Freycinet National Park

Wineglass Bay Carpark and Lookout Track Site Plan 2004

Report to the**General Manager****on****Public Representations Received on the *Freycinet National Park Draft Wineglass Bay Carpark and Lookout Track Site Plan 2004***

**Schedule of Public Comments and Proposed Responses
to the
Freycinet National Park Draft Wineglass Bay Carpark and Lookout Track Site
Plan 2004**

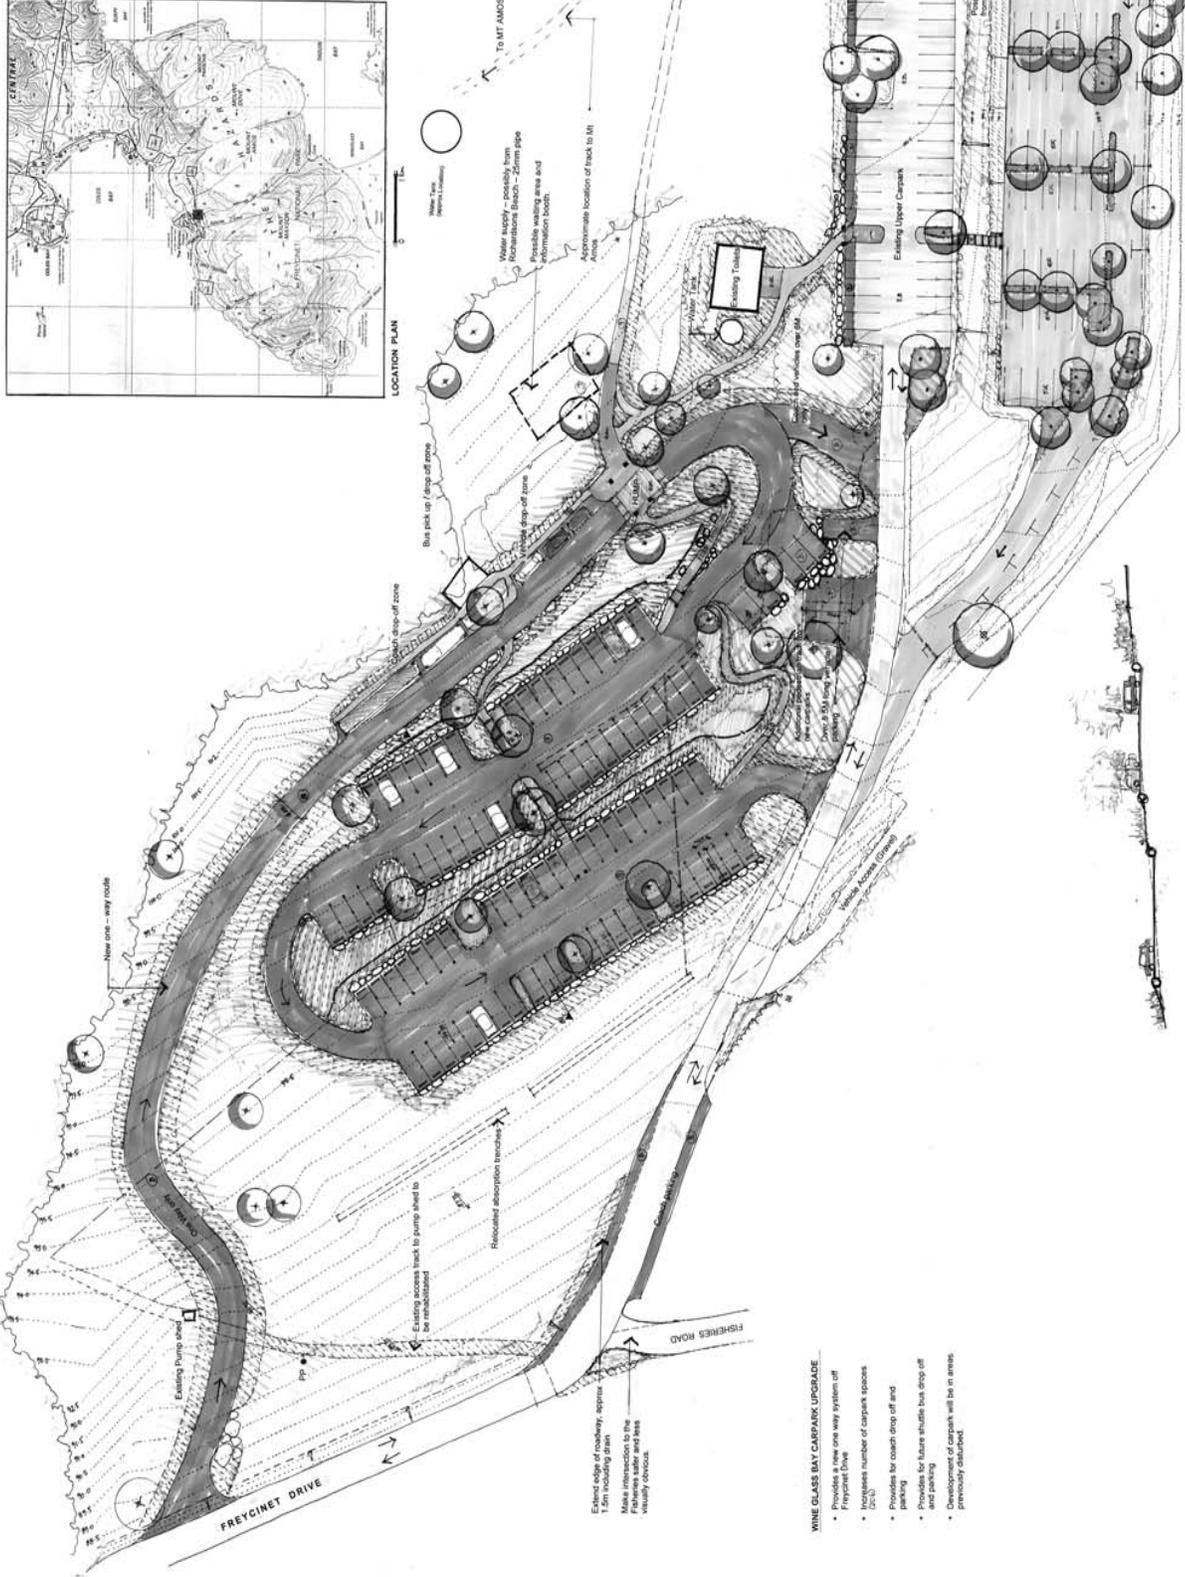
5. Frequent walker in the park	Noted.
6. I. The plan fails to recognise the substantial impact the expanded carpark will have on landscape and visual values. The carpark expansion will lead to: 'substantially increased visibility of cars and alienated ground from numerous higher vantage points, eg from the Mt Amos track.'	It is accepted that the plan, in considering visual sensitivity, focussed on views to the Hazards and failed to consider views from the Hazards. The carpark will be visible by walkers looking down from the many vantage points on the Hazards, and will impact on the overall naturalness of views obtained.

13. Very concerned for the proposed coach parking area between the two Fisheries turn-offs. It will obstruct the view of traffic exiting the fisheries, creating a dangerous situation.	This comment will be referred to the carpark's design engineer for his comment, and, if deemed appropriate, design amendment.

Comment	Proposed Response
27. 4.1 Disagree with doubling the current carpark size. It will have visual impact, and its overall effectiveness is questioned. The numbers put up in the site plan indicate the limit requiring alternate solutions has already been reached.	See response to comments #6 and 7.

Comment	Proposed Response
	<p>In considering this issue several ameliorating aspects are apparent, viz:</p> <ul style="list-style-type: none"> • The carpark is right next to a fairly intensely developed holiday residential area at the Fisheries, and will, when seen from above, read as an extension to it. • The new carpark will be sealed, providing a much lower reflectivity and visual contrast to an unsealed carpark. It is however accepted then when the carpark is full the vehicles themselves are highly reflective. • The existing large trees across the new carpark site have been, to the extent possible, incorporated into the carpark design. They will provide substantial screening when viewed from above. • In the long-term it is planned to reduce the amount of carparking at the site, thereby reducing the overall impact. <p>In conclusion, while accepting that the carpark will impact on views from above, it is believed the issue is not sufficiently serious to warrant a major rethink of the current approach.</p>

Figure 2 - Lookout Track Site Design

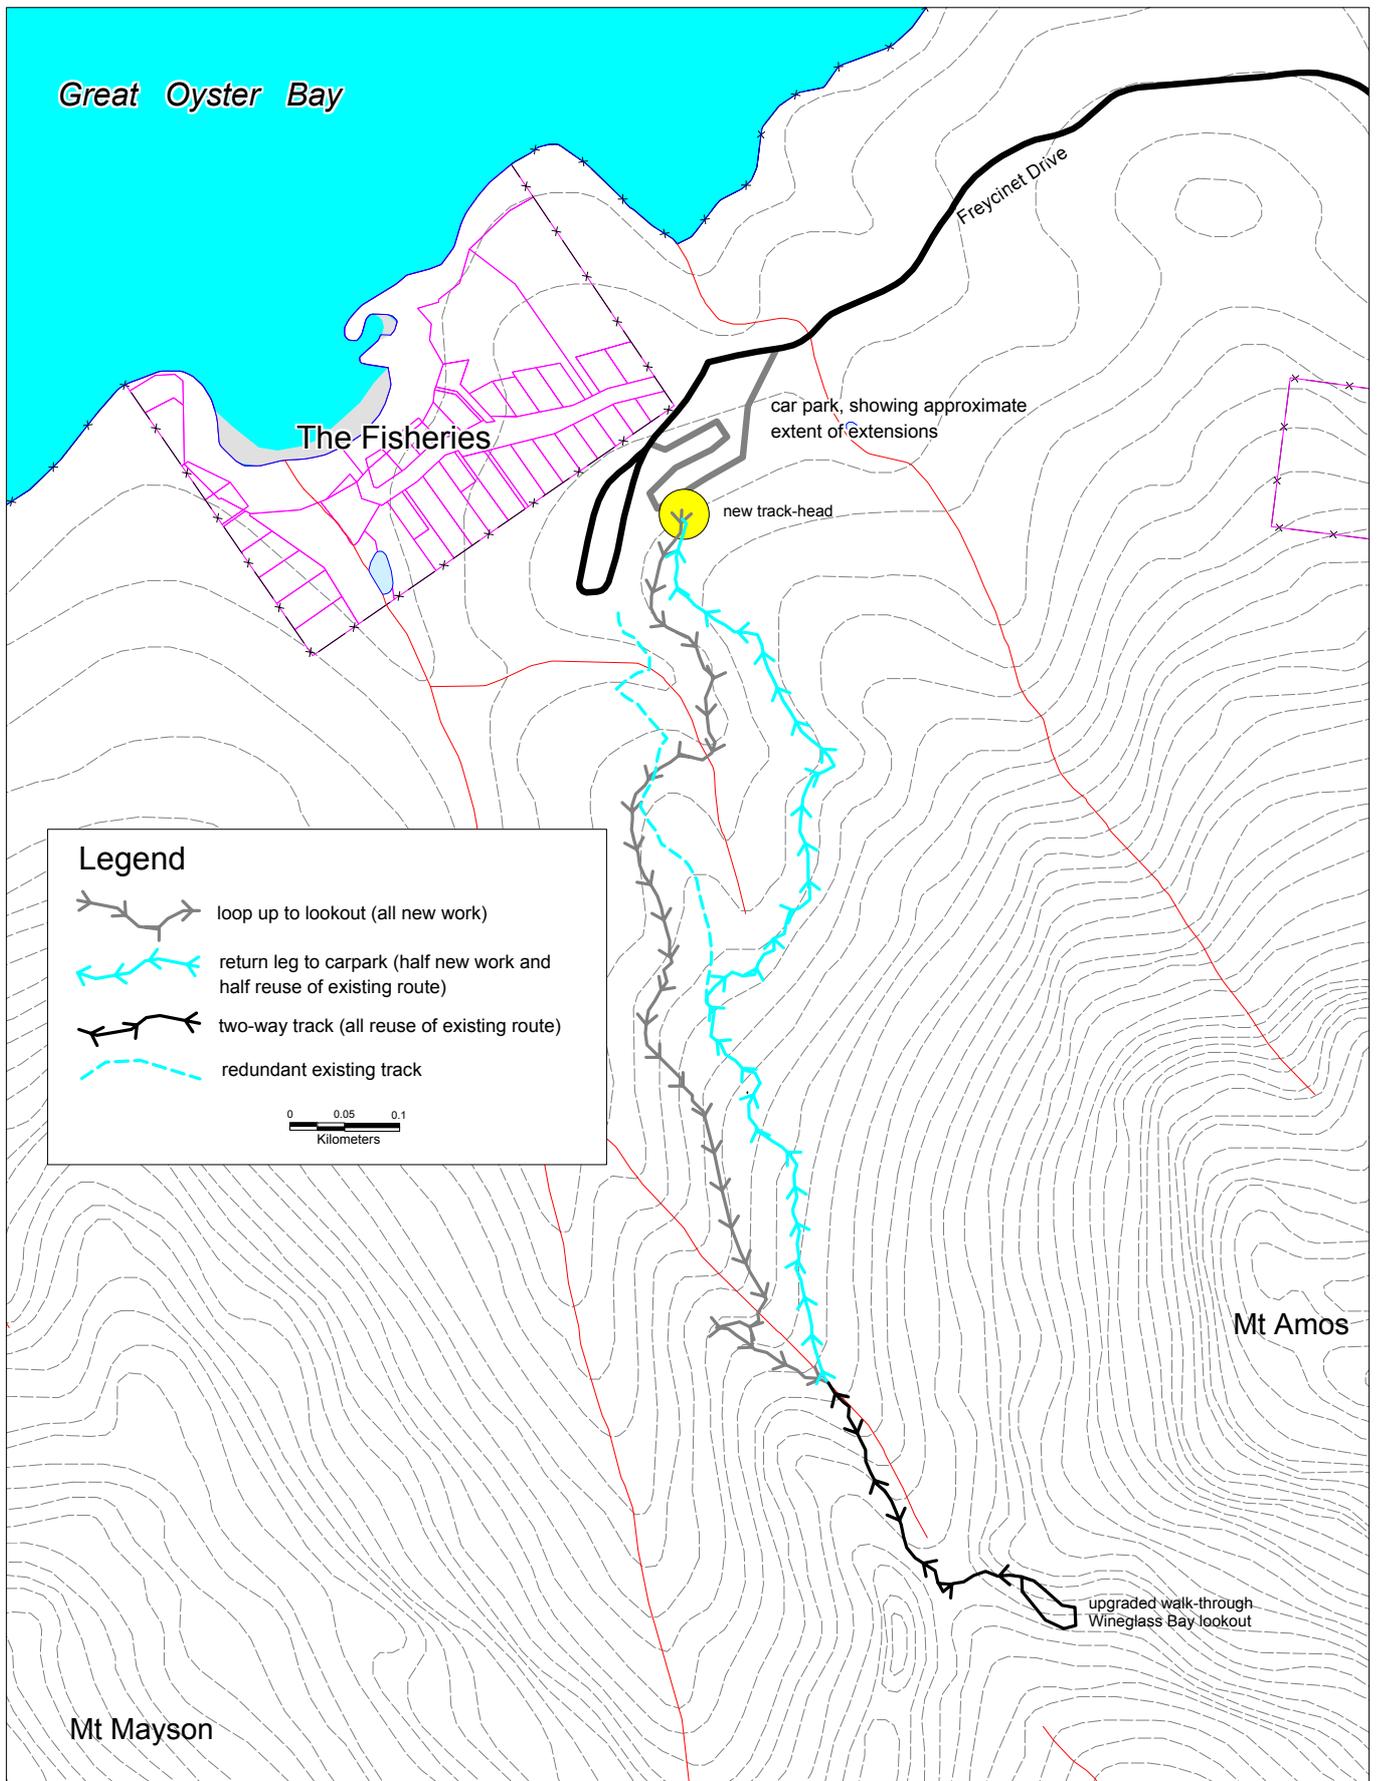
10. IV. Strongly disagree with a one-way traffic system on the loop track, it being too regimented and also increasing the frequency of overtaking encounters.	See response to comment #11.

30. Track Plan Rather than a mostly one-way system, suggest two 2-way tracks, one slower and gentler, the other faster. The reason for this being that there are many users who progress very slowly, causing frustration for fitter, faster walkers.	See response to comment # 11.

56. Track Plan Support the loop system, but disagree with making the return downhill loop the shorter, steeper leg. For safety it should be the other way round.	The management authority acknowledges this concern and considers the respondent may well be right. This is the reason for the wording of Section 4.3 which says: While an anti-clockwise circulation pattern is currently being proposed, a final assessment of the correct circulation pattern will be made once construction has been completed. In any case these comments will be forwarded to the track design team.

11. Respondent prefers to walk against the traffic on a one-way system. The respondent finds being stuck behind a large group of people is frustrating. This problem would be exacerbated by the introduction of shuttle buses. Passing bays are an inadequate response. Both tracks should be two-way.	<p>It is noted that the proposed changes may cause the respondent some frustration. However the creation of one relatively short length of one-way loop track in a park that has many more kilometres of two-way track is considered acceptable.</p> <p>The Wineglass Lookout is one of Tasmania's premier tourism icons. As visitor numbers increase it is important that the experience be carefully managed to maintain quality. Feeling overcrowded has been demonstrated to reduce the quality of natural area experiences.</p> <p>Development of a one-way loop track system is a well-recognised approach to managing this issue. At the heart of the concept is a major reduction in apparent level of crowding. Parties move around the system at approximately the same speed, minimising encounters with each other.</p>
